St Aloysius Junior School Concept plan (part of SSD 8669)

I act on behalf of the residents of Crescent Place and Bligh Street Kirribilli that own properties facing the Junior School site. I have been requested to provide an independent planning opinion regarding the proposed Concept Plan for St Aloysius School as it relates to the Junior School Campus.

**GEOTECHNICAL ISSUES
PROPOSED MULTI-PURPOSE SPACE DEVELOPMENT
ST ALOYSIUS JUNIOR SCHOOL
BURTON STREET, KIRRIBILLI, NSW**

Figure 1 – streetscape of Crescent Place

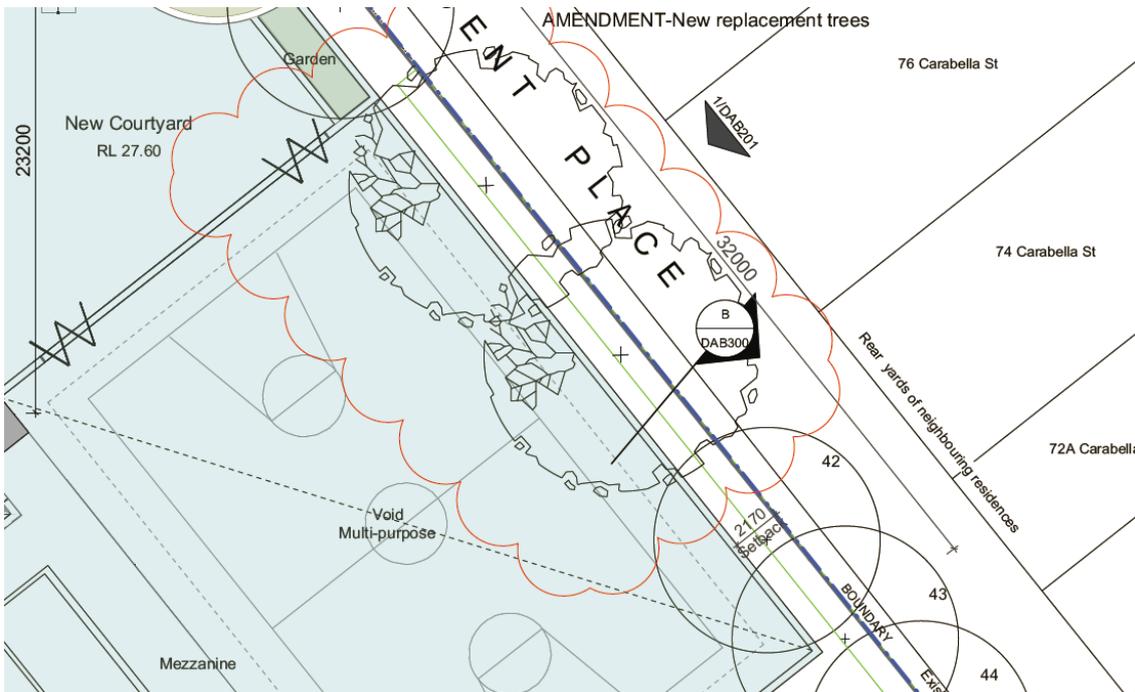
The proposal will have a significant visual impact on Crescent Place and Bligh Street as it will present a large wall very close to the boundary without any opportunity for meaningful vegetative screening. The existing character of Crescent Place which is a very narrow street (only 5.5m wide), is relatively open, with the school currently having no major structures along the street frontage and the residential development opposite being generally single storey in scale (see **Figure 1**).

Figure 2 – minimal setback to Crescent Place

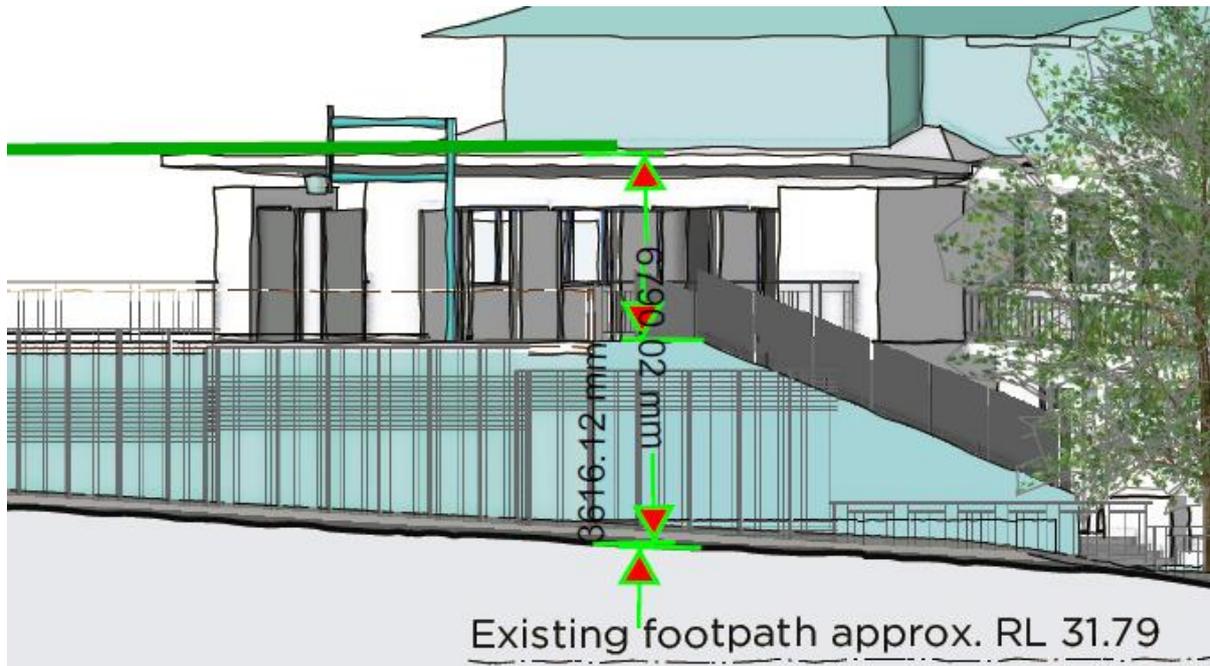
As can be seen on drawing DAB 122, the wall of the proposed multi-purpose space is setback only 2.17m from the boundary (see **Figure 2**). Further, DAB201 shows that wall of the structure will be in part, up to 3.6m above the footpath level (see **Figure 3**). However, this drawing does not show the fencing that would be required around the outdoor space located on the roof of the structure. This would be likely to add a further 3-4m to the built form (based on the plans which do show a high fence, in part), meaning that a structure of around 6.6-7.6m will present to the street only 2.17m from the boundary.

Figure 4 – indicative relocation to provide 5m street setback

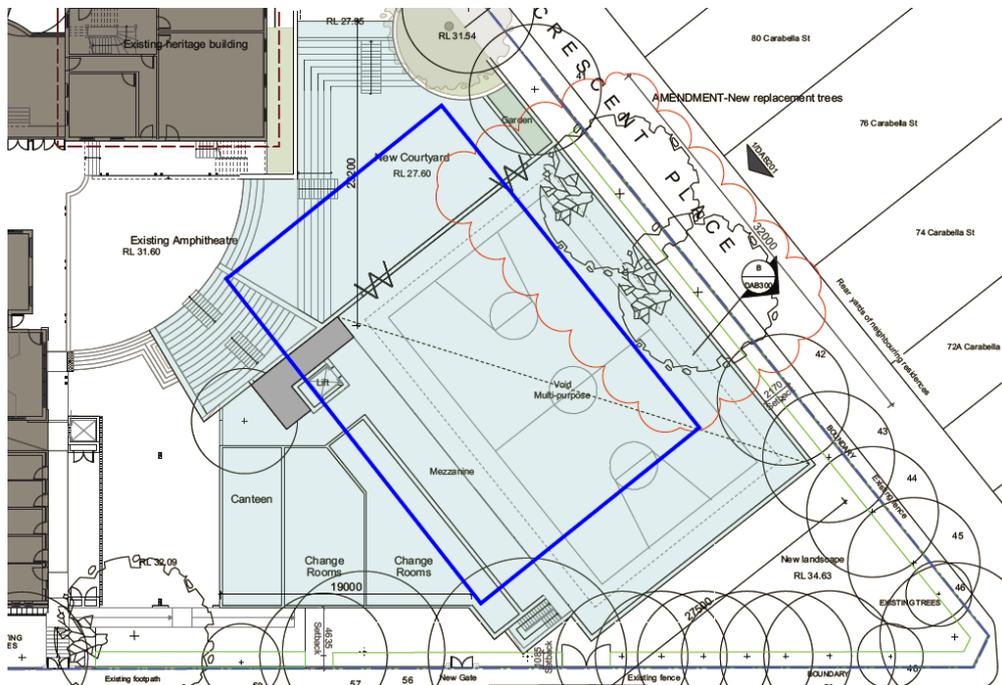
In light of the above, and given that the proposals for the Junior School are only 'concepts' at this stage, it is appropriate that the permitted 'envelope' for development be amended now to ensure that resolution of very important issues is not left for future stages when there would be an expectation that envelopes indicated on current plans are 'approved' and do not require substantive change. In this regard, in order to mitigate the significant impacts outlined above, it is requested that the following condition be adopted:

The proposed Junior School multi-purpose facility is to be setback a minimum of 5m from the boundaries to Bligh Street and Crescent Place and the existing trees along these street frontages are to be retained and adequately protected during construction.
